ADDENDUM No. 1

Date: JULY 3, 2019 *TCVN*
Owner: GREEN RIVER VALLEY WATER DISTRICT
Project: CONTRACT 1 – WATER TREATMENT PLANT EXPANSION

BLOWOFF ASSEMBLY DETAIL

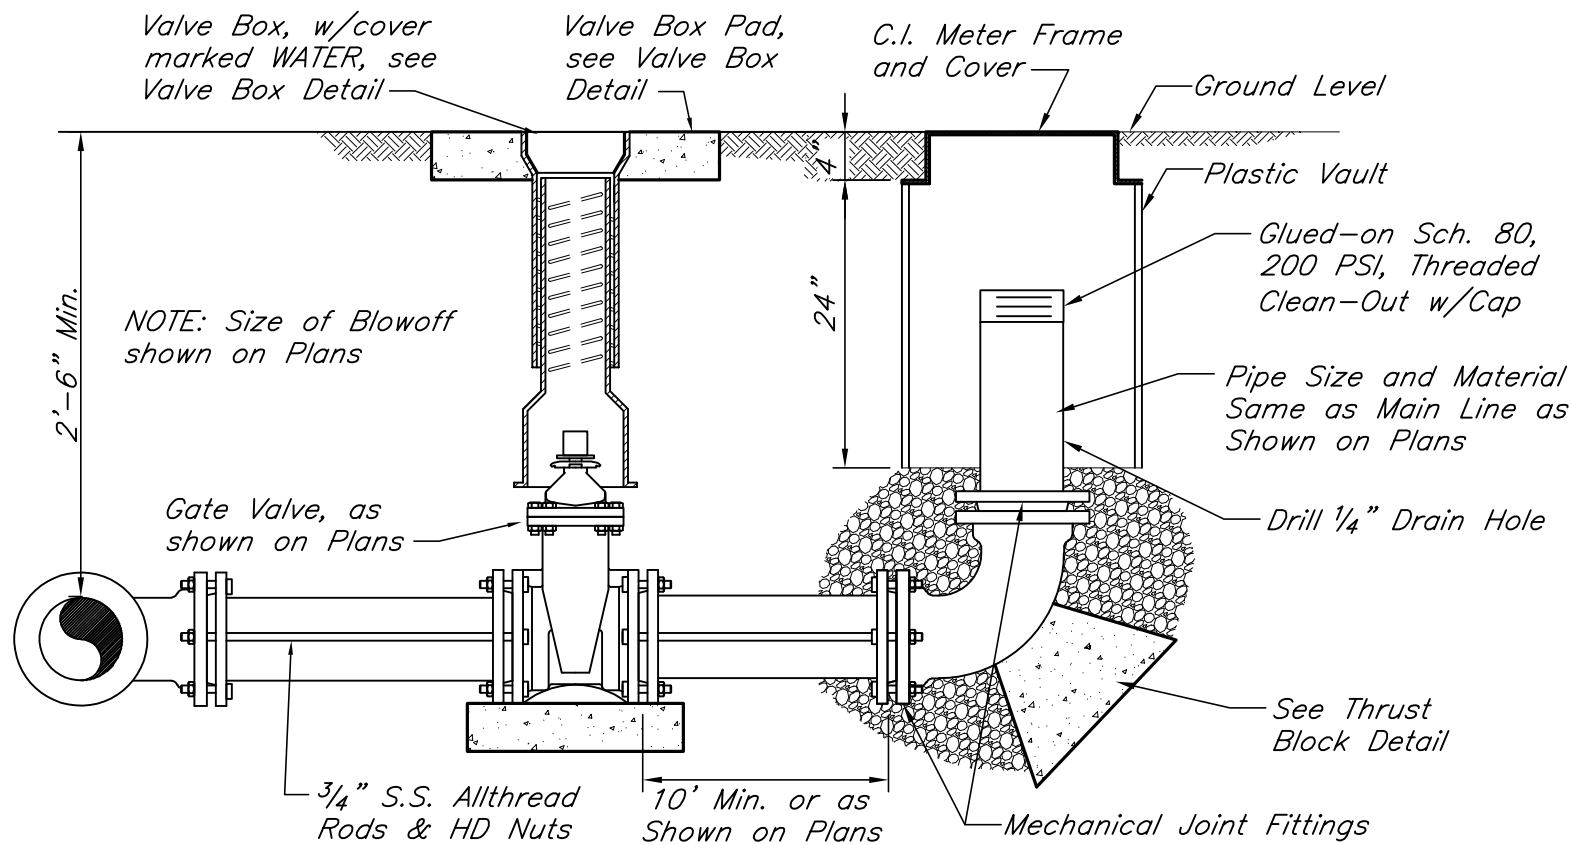
29. **Sheet 2.1, River Intake Improvements Site Plan** – Attached is a detail for the 6" Blowoff Assembly.
30. **Sheet 3.1, Spring Water Pump Station** – The 4" Service Water line shown in the Plan view and located between the building and the 4' manhole does not get constructed. The 4" Service Water line shall be constructed as shown on the Sections A/3.1 & C/3.1.

3
 S7.5
 DETAIL
 1"=1'-0"

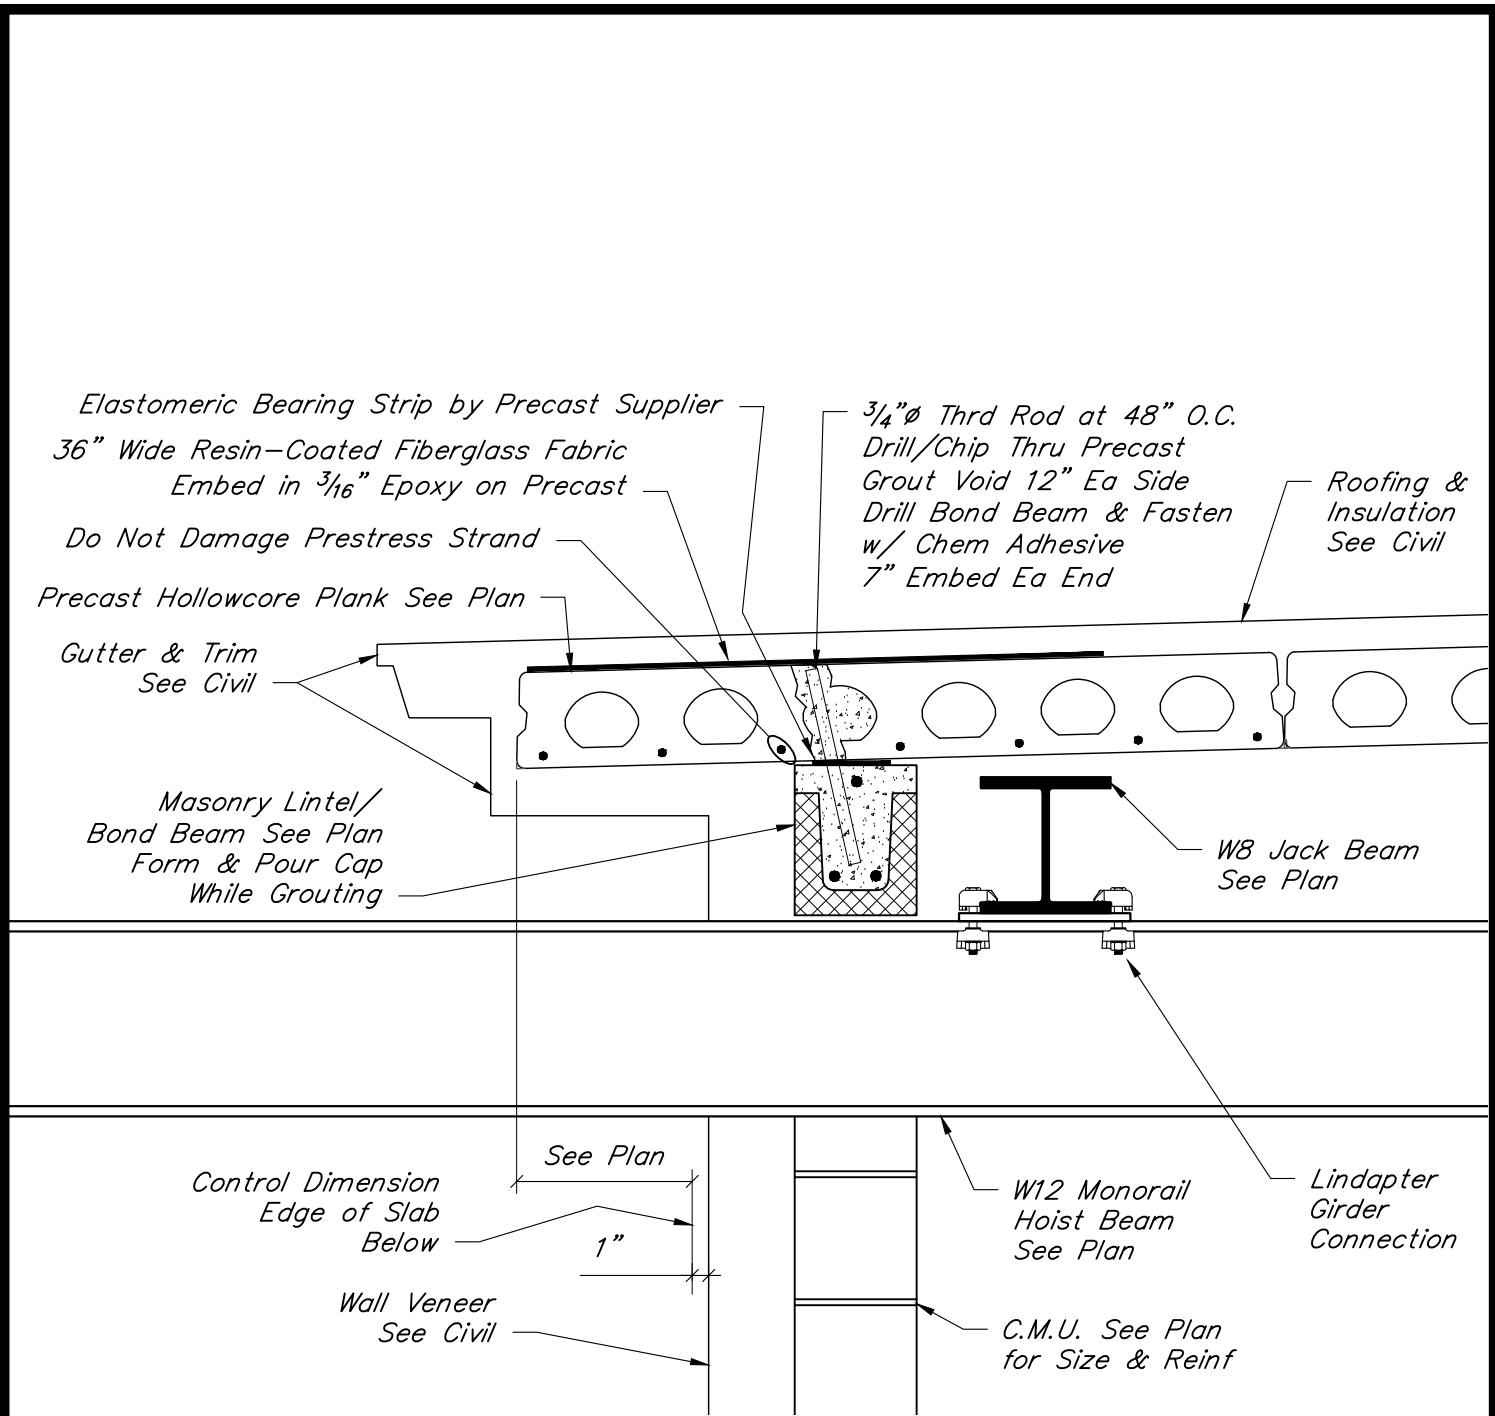
- 35. **Sheet S3.1 & S5.3, Aluminum Grating** – The grating type called out on the plans is incorrect. The grating shall be as specified in Section 05530.2.05.B.
- 36. **Sheet S7.5, Detail 3** – Attached is a reprint of Detail 3 since portion of the text was cut-off.
- 37. **Sheet S7.5, Section C** – The caps for the two (2) drilled piers shall be 3'-0" square x 2'-0" deep as called for on Sheet S7.5.
